# P802.3bt D3.0 – Dual-signature LLDP v153

This is an overhaul for the LLDP specification in Clause 79, specifically addressing dual-signature operation. It aims to address the issues raised in comments #130, #293, #294, #296, and #297.

Figure 145–39—PSE power control state diagram for single-signature PDs

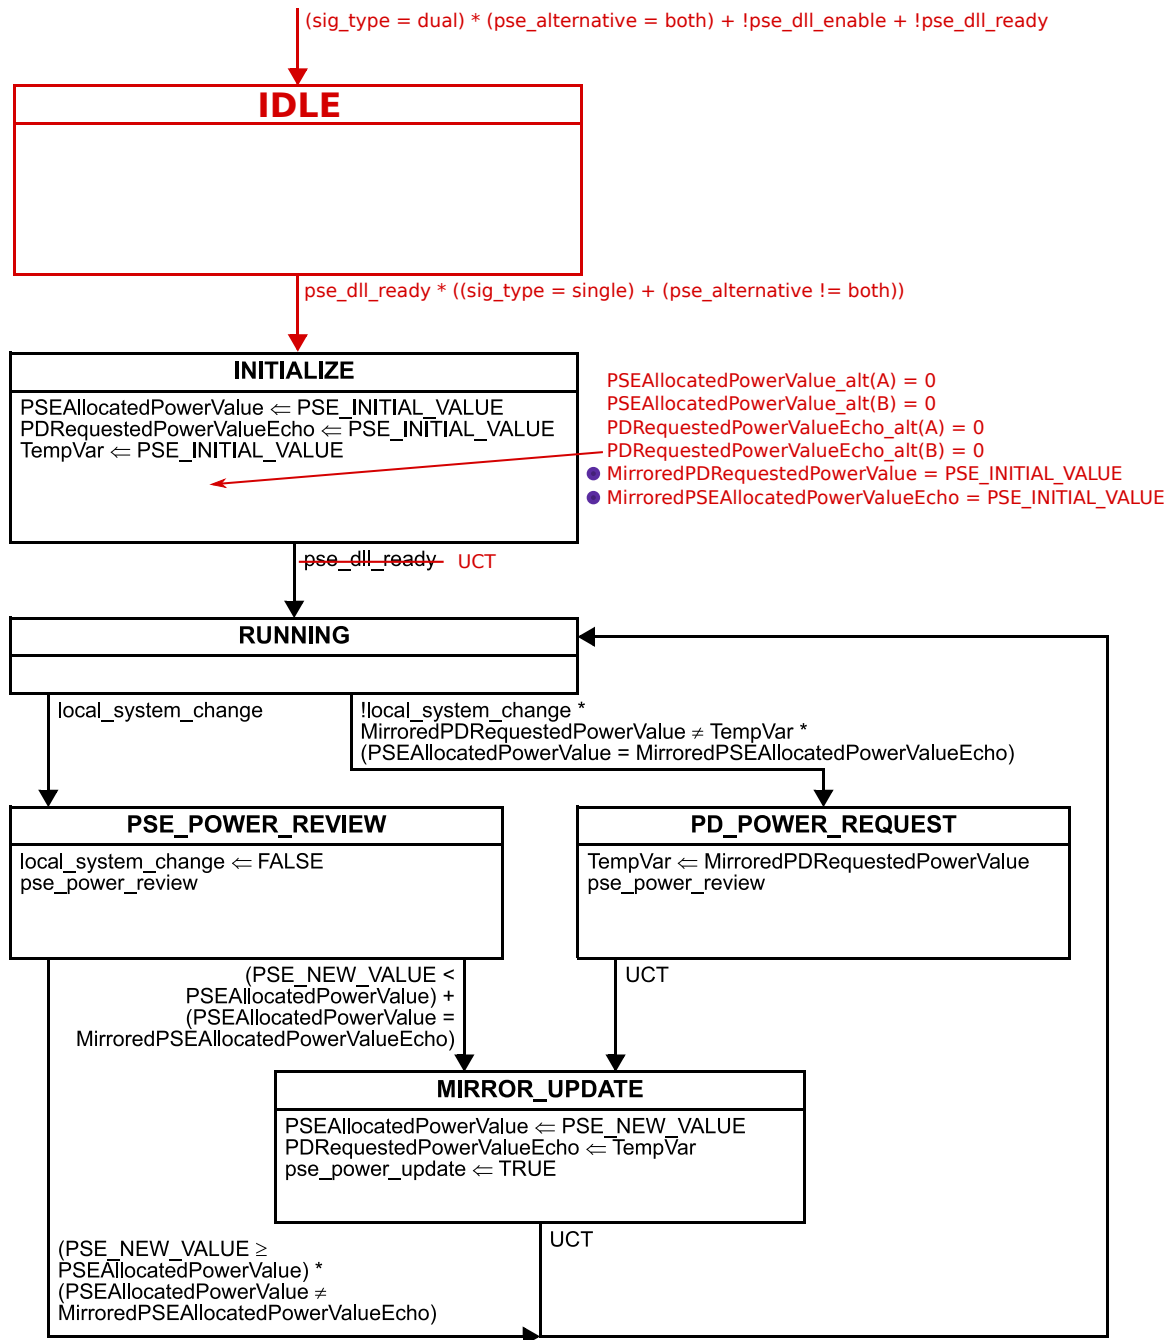
This is one of the three state diagrams that the PSE needs to run. It sits in IDLE whenever DLL isn't enabled or not ready, or when the other state diagrams need to be in control (dual-signature detected). It proceeds to INITIALIZE when DLL is ready and the PD is a single-signature, or the PSE is restricted to 2-pair operation.

Also fixed is the issue where Mirrored\_\* variables are read before they are set. Mirrored variables contain the contents of incoming LLDPDUs and get set only when a frame is received. During the time between the first frame being received and DLL being enabled, their value is undefined. Fixes related to this issue are marked with a purple circle.

Change Figure 145–39 as follows:

Figure 145–41—Single-signature PD power control state diagram

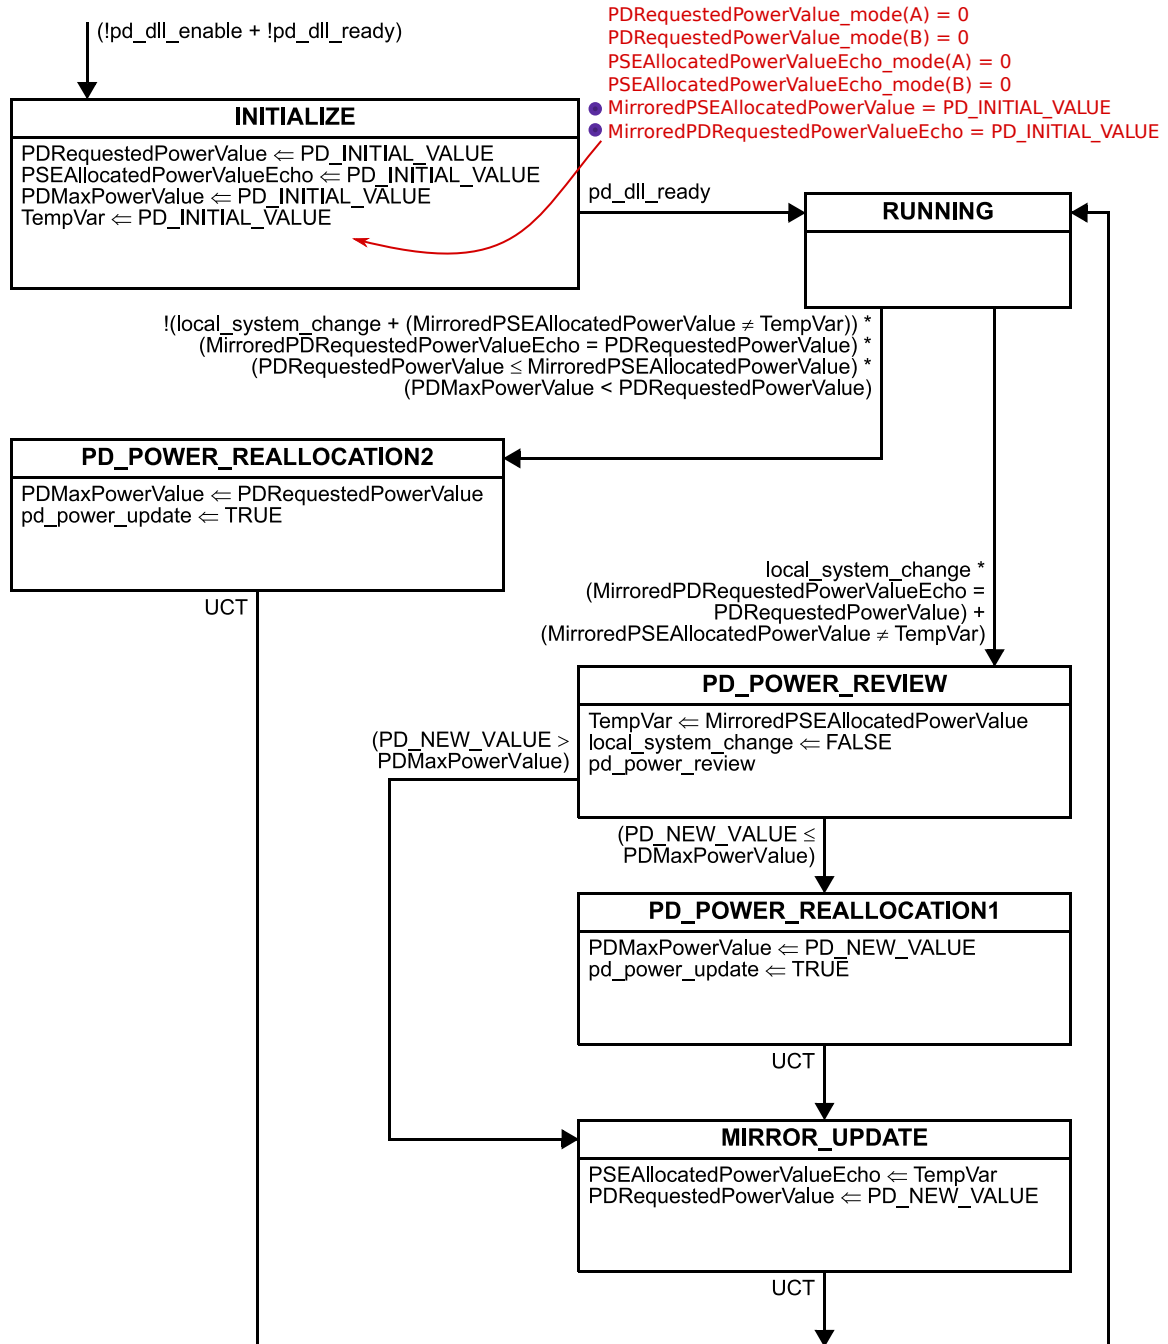
This is the state diagram for single-signature PDs. By setting the A/B fields to zero in INITIALIZE we have made this state diagram self-sufficient for single-signature. The other state diagrams intended for dual-signature do not need to run (as reflected in the text earlier).

Change Figure 145–41 as follows:

Figure 145–43—PSE power control state diagram for dual-signature PDs in 4-pair mode

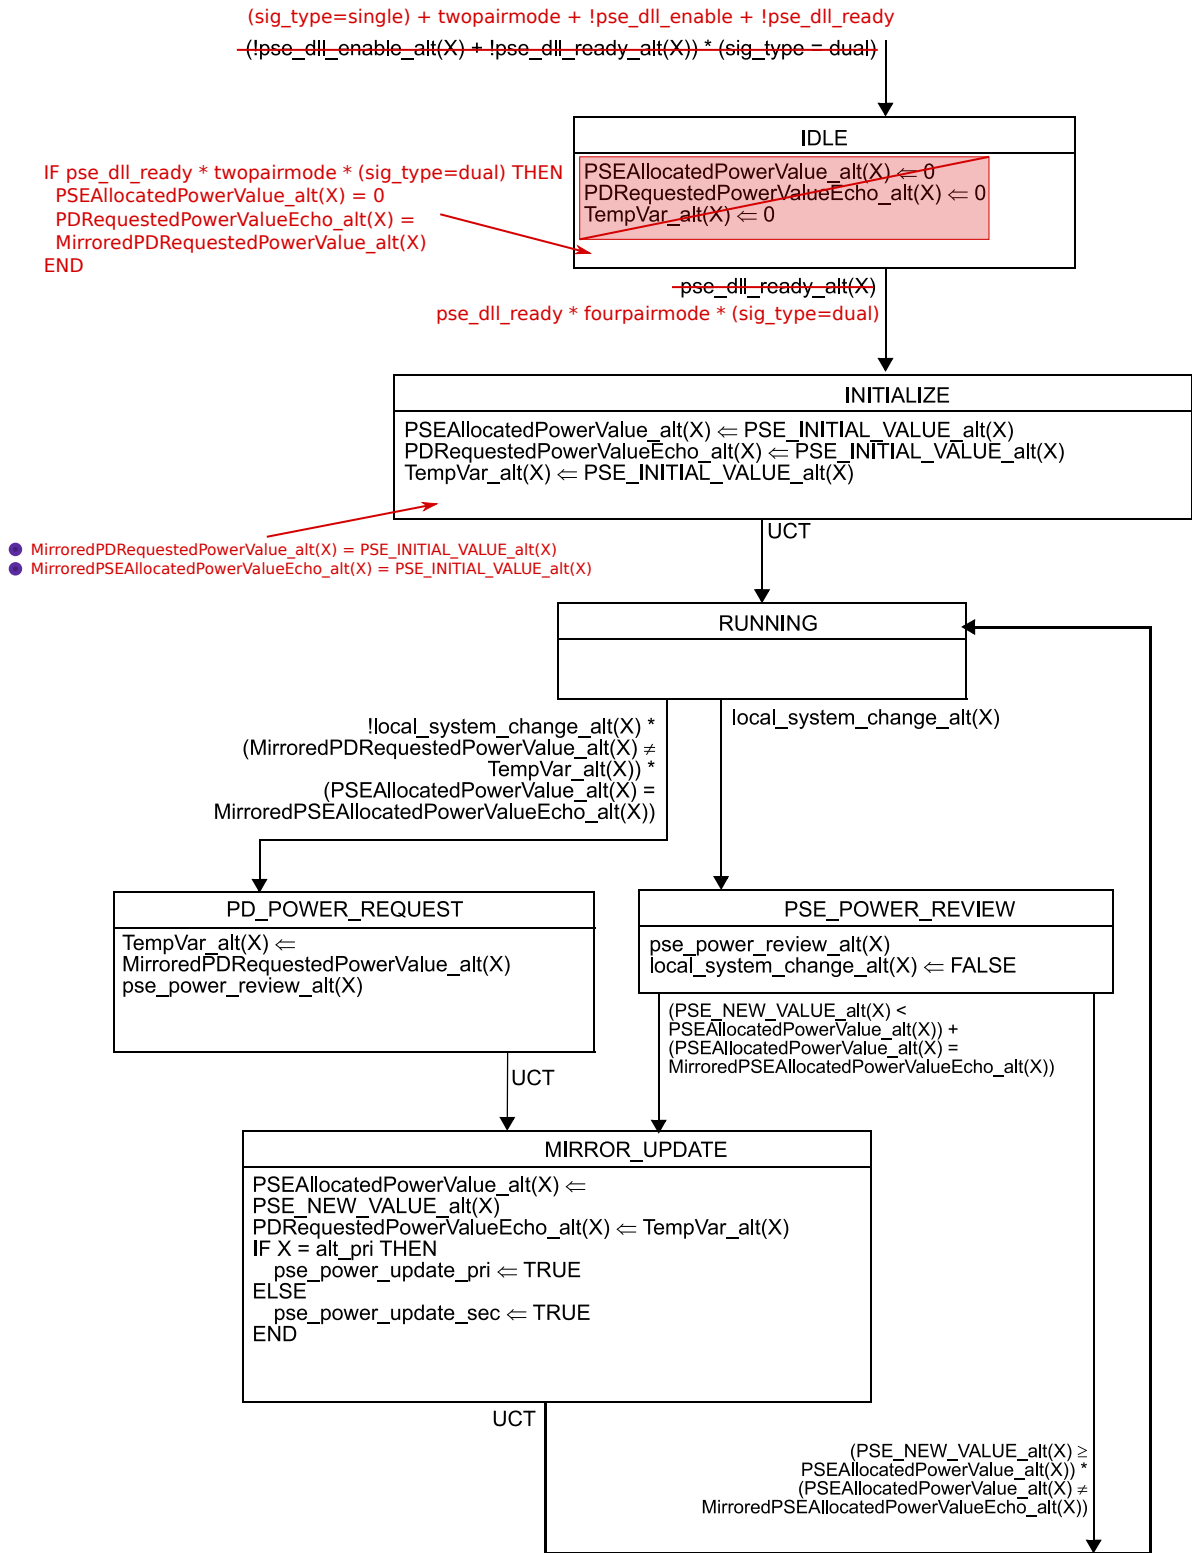
Change Figure 145–43 as follows:

Figure 145–43a—PSE power control state diagram for dual-signature PDs in 2-pair mode

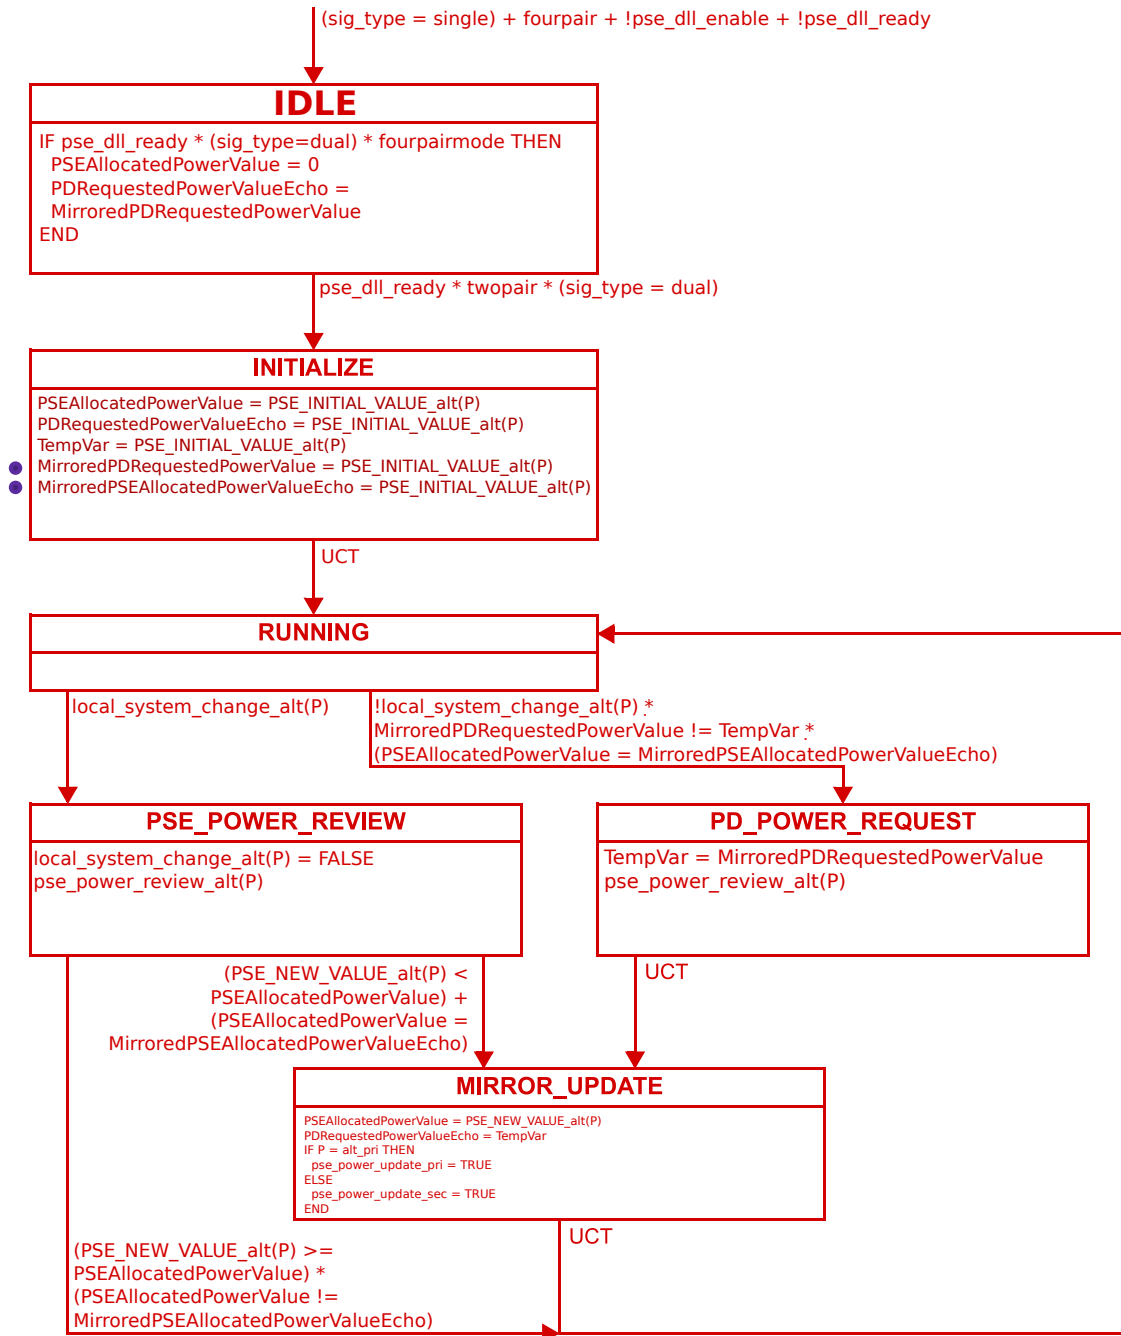
Insert Figure 145–43a as follows:

Figure 145–44—Dual-signature PD power control state diagram for 4-pair mode

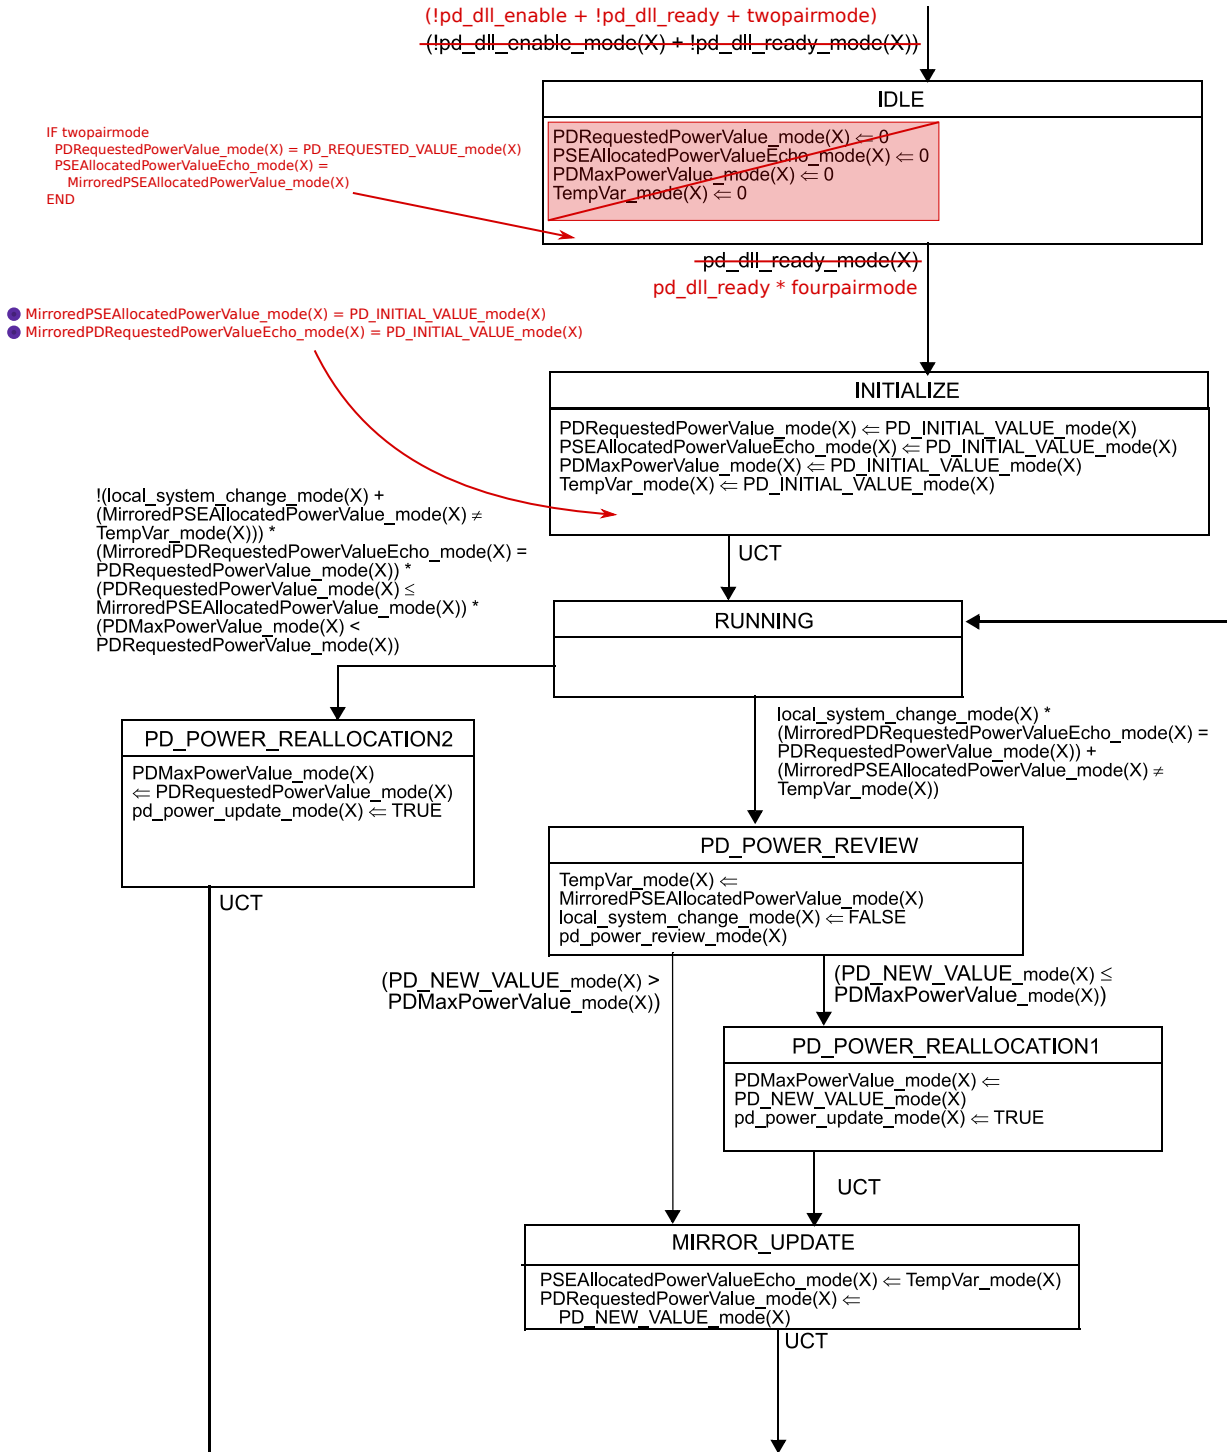
Change Figure 145–44 as follows:

Figure 145-44a --- Dual-signature PD power control state diagram for 2-pair mode

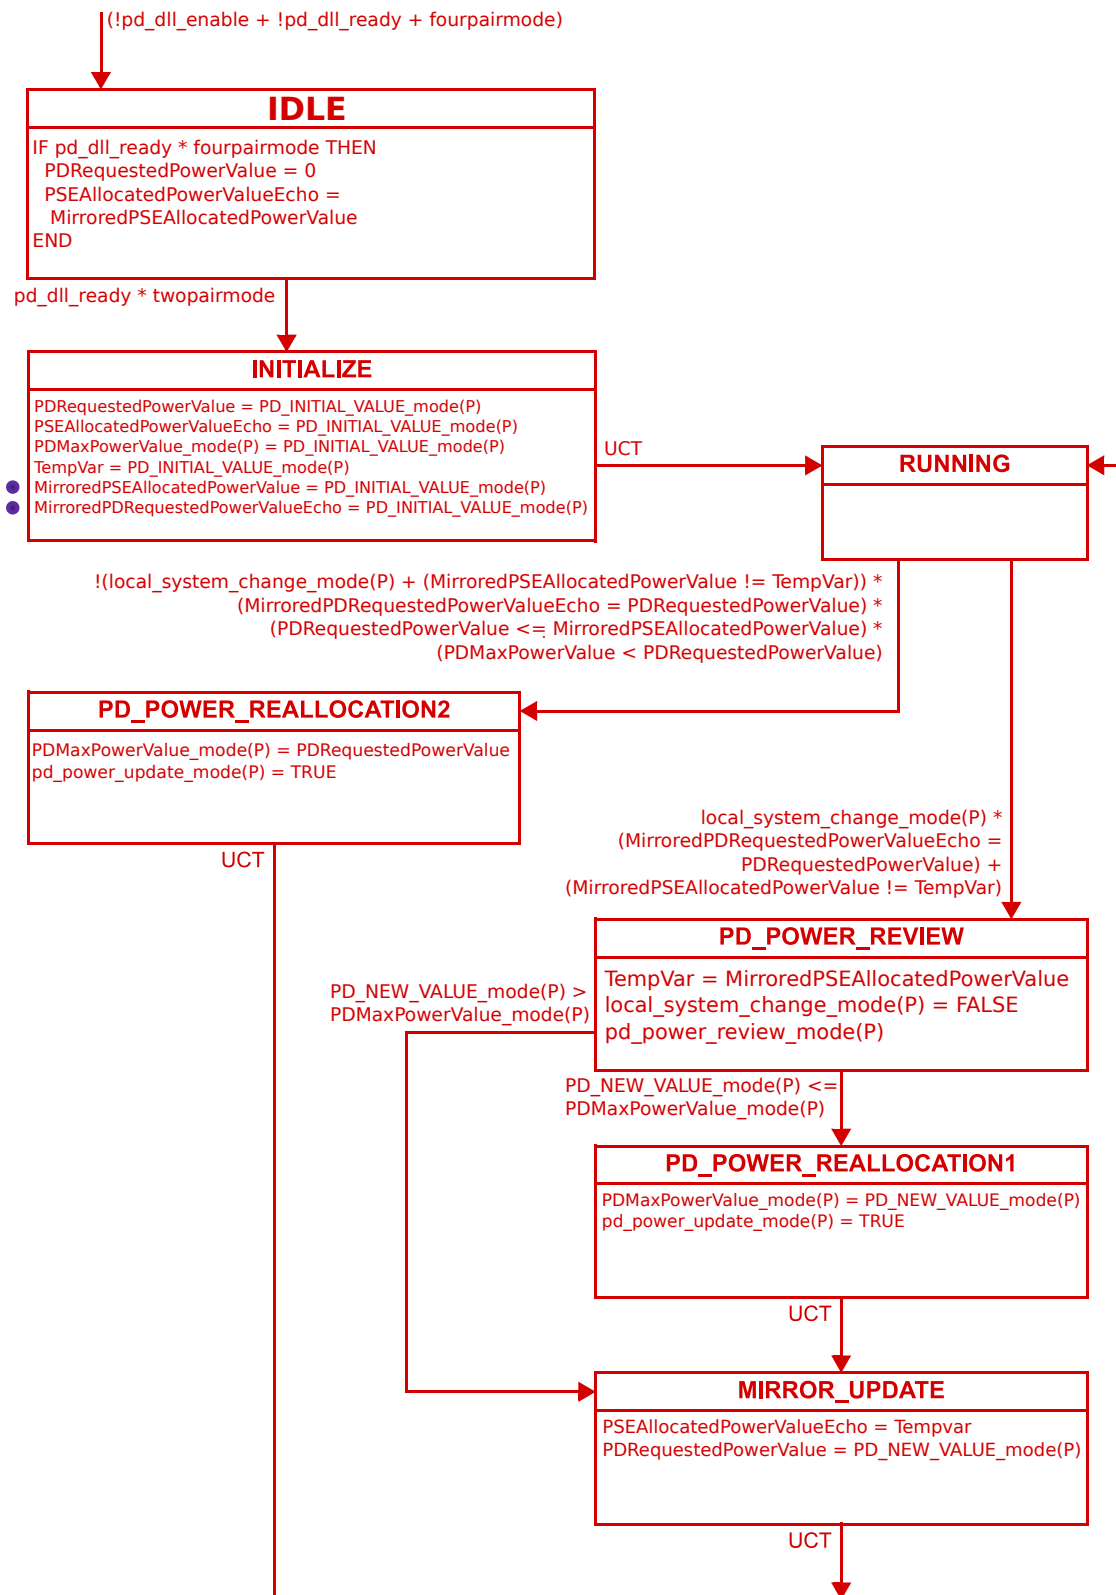
Insert Figure 145–44a as follows:
